BAR # 22-12-02

116 West Jefferson Street, TMP 330183000

Project: Porch reconstruction, alterations to rear addition

**City of Charlottesville  
Board of Architectural Review  
Staff Report  
December 20, 2022**

**Cornice at 116 West Jefferson St**

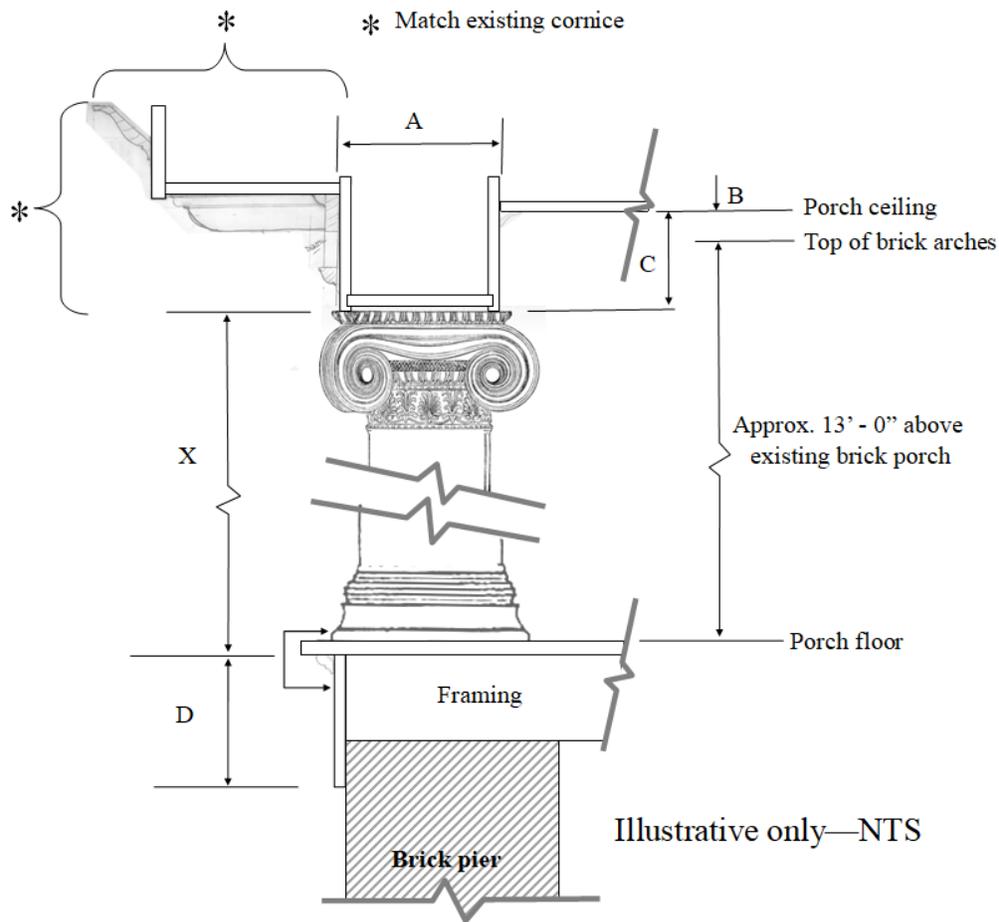
Existing cornice at 116 West Jefferson Street. New porch cornice to match.

116 West Jefferson Street (existing) – note ceiling board and trim

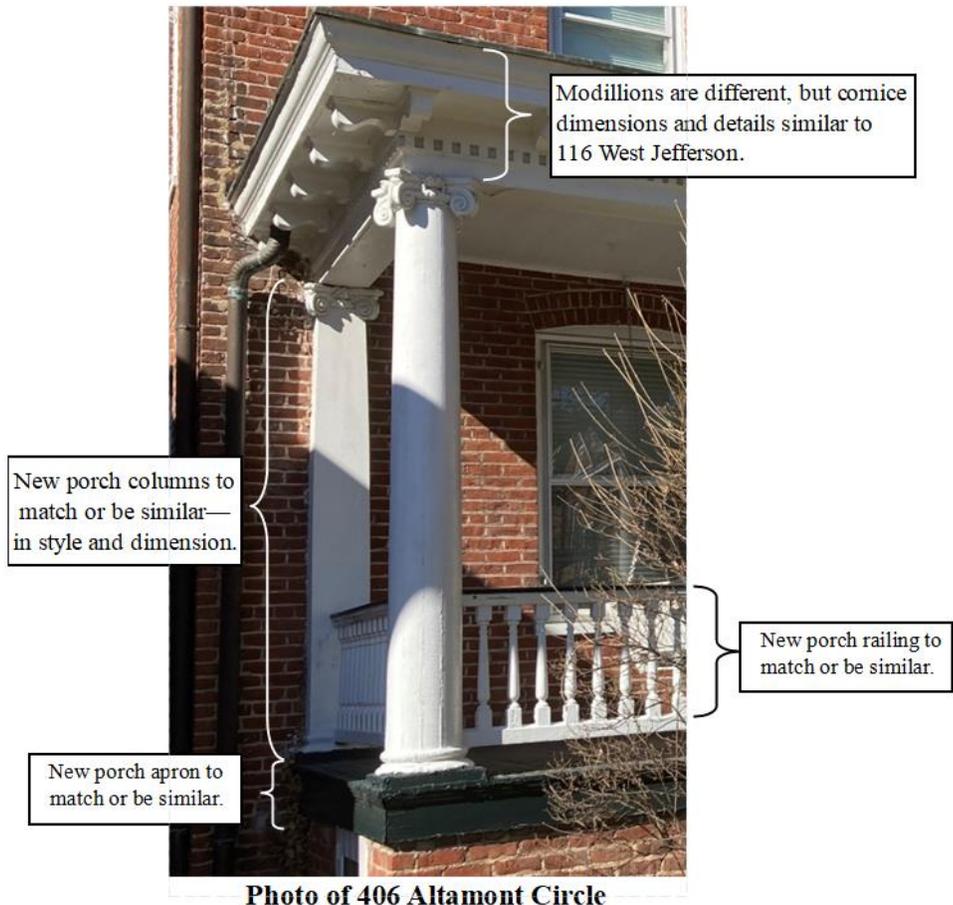
- Ceiling: Beaded-board with simple cove or crown at entablature, similar to existing ceiling at rear, upper porch. Porch ceiling will be above—and encroach onto—the brick arches above the entry and two windows. Painted. Color: TBD. \*

**PORCH CORNICE DETAIL TO MATCH EXISTING**

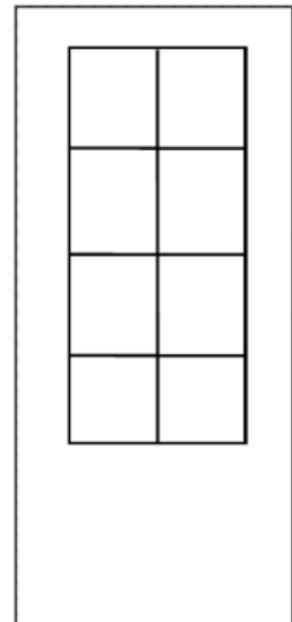
Detail from porch reconstruction at 201 East High Street. [Reference is to gutter condition only.]

**Revised detail 4 on Sheet A-3**  
 Add simple crown mould, similar profile and proportions to that shown in Fig 7 of the July 2019 BAR submittal (below). Available, stock profile is fine.

- Roof: Original roof was standing-seam metal. New roof to be standing-seam metal.
- Gutters and Downspouts: Original porch had built-in gutters; new gutter type not specified. In lieu of the built-in gutter, if not replicated, staff suggests a detail similar to that approved for 201 East High Street. \*

**EXTERIOR ELEVATION - SOUTH AT BALCONY**  
116 WEST JEFFERSON STREET

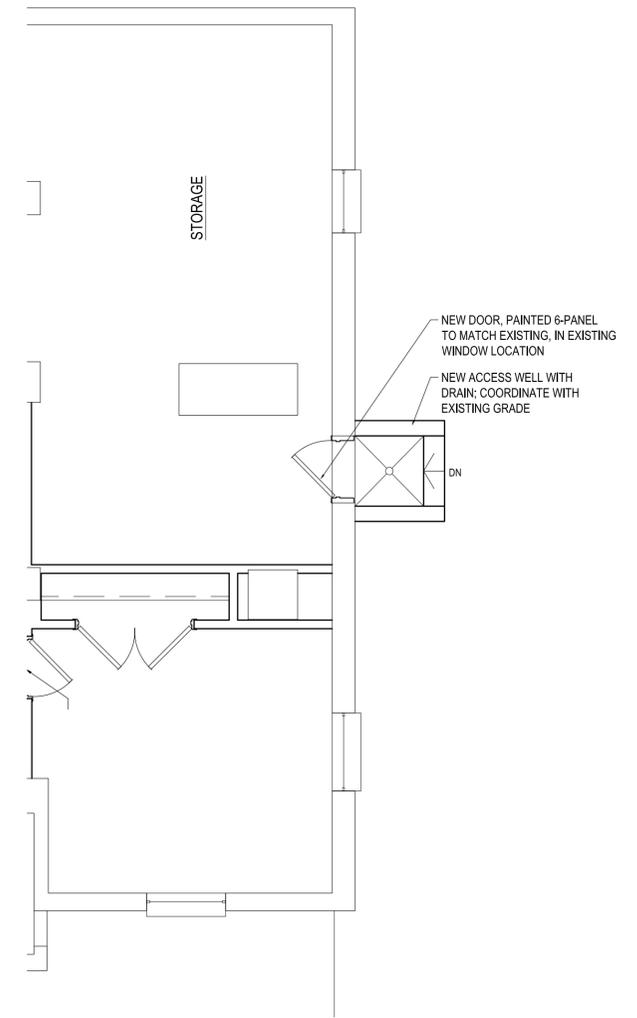
NEW DOOR AT EXISTING WINDOW LOCATION,  
PAINTED 6-PANEL WOOD DOOR TO MATCH EXISTING.

- On the 1913 house, the two new doors (frame and trim) will not alter the height, arch, or width of the existing masonry opening. Necessary brick repairs will be toothed-in, not saw cut, and use an appropriate mortar mix (lime vs Portland cement). The historic windows removed will be retained on the site and properly stored to allow later re-installation, if/when that occurs.

**South Elevation—Contemporary Addition**

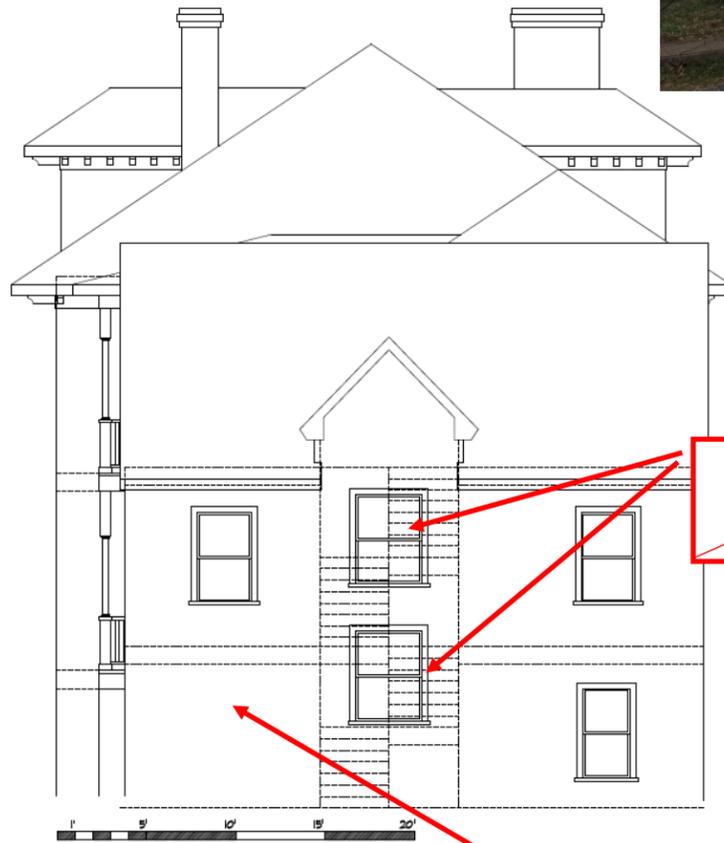
**Install larger windows**

**Remove door and canopy**

Move window down.  
Repair wall to match.

- Applicant will provide for staff review cutsheets for alterations to the windows and doors at the rear contemporary addition, with the understanding that the windows will not be vinyl, but may be wood, aluminum-clad wood, or fiberglass composite.

Connector

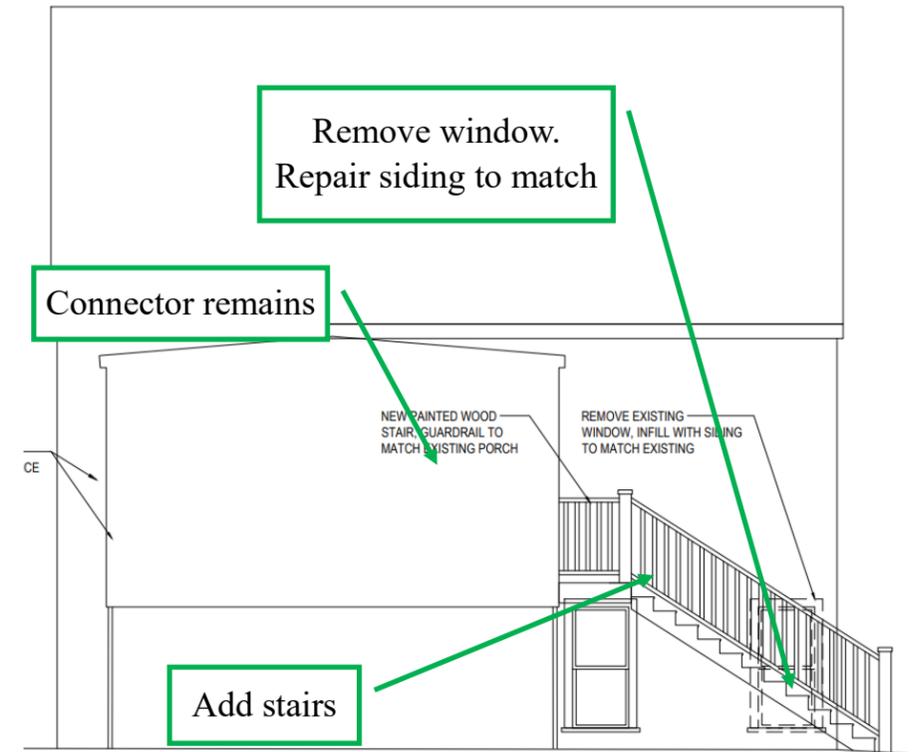
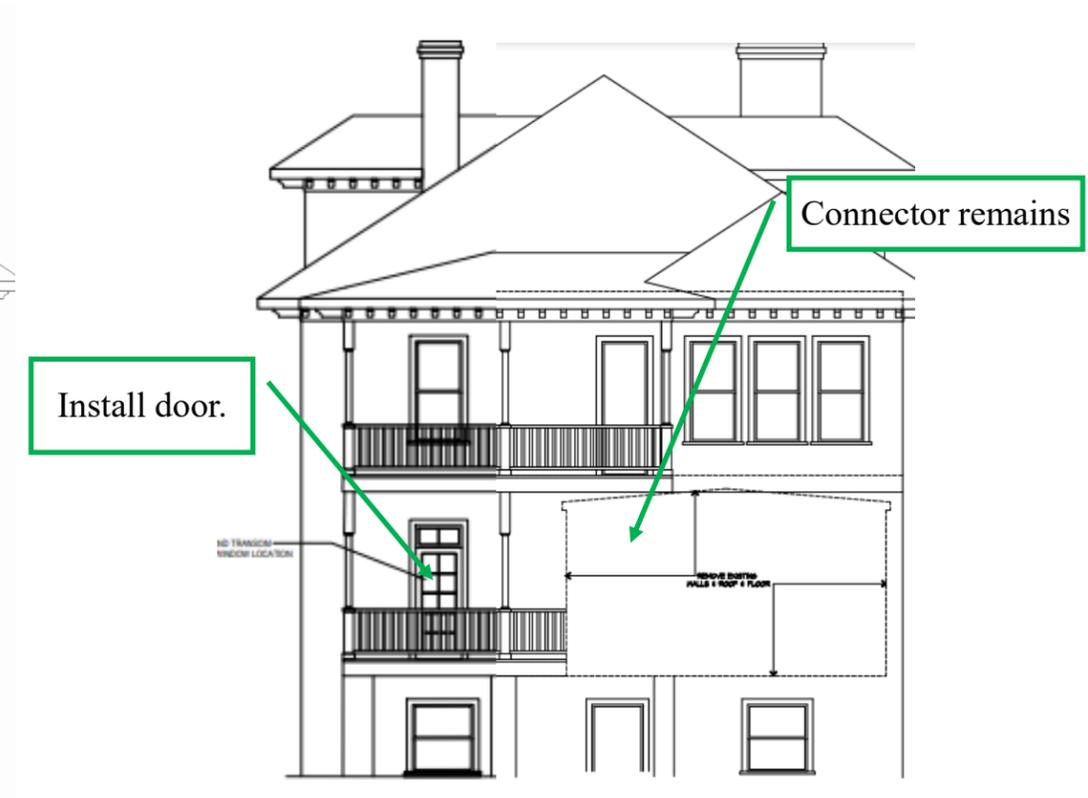
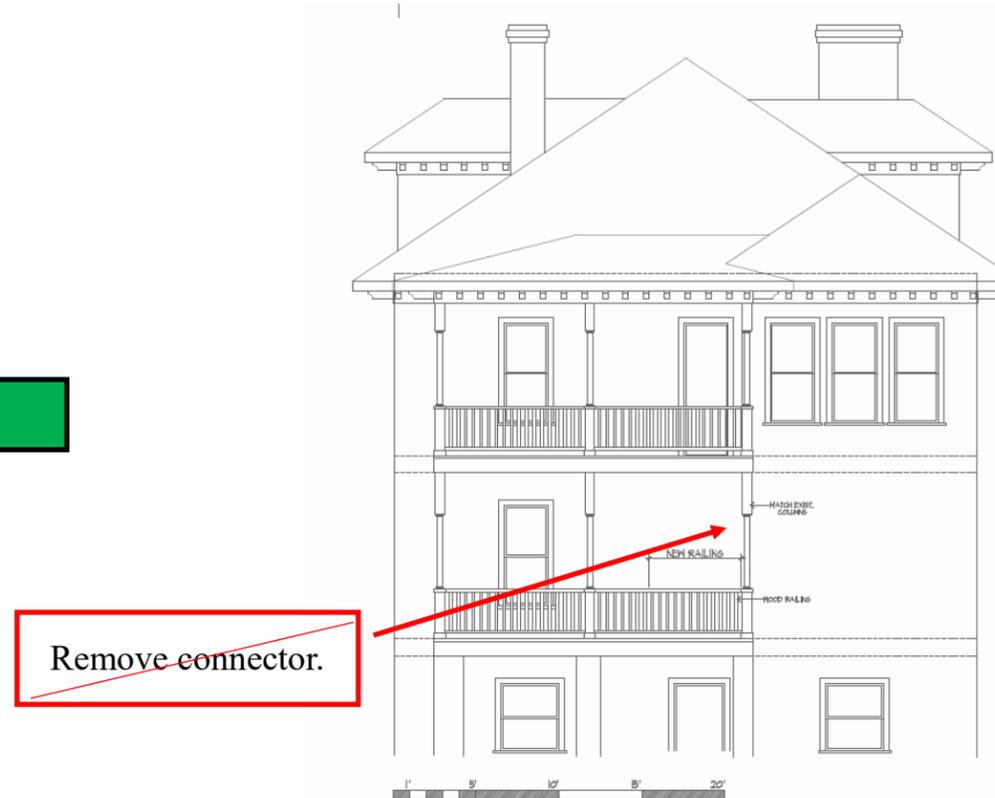
Construct painted wood stairs and install new door at west elevation. Railing detail to match rear porch.
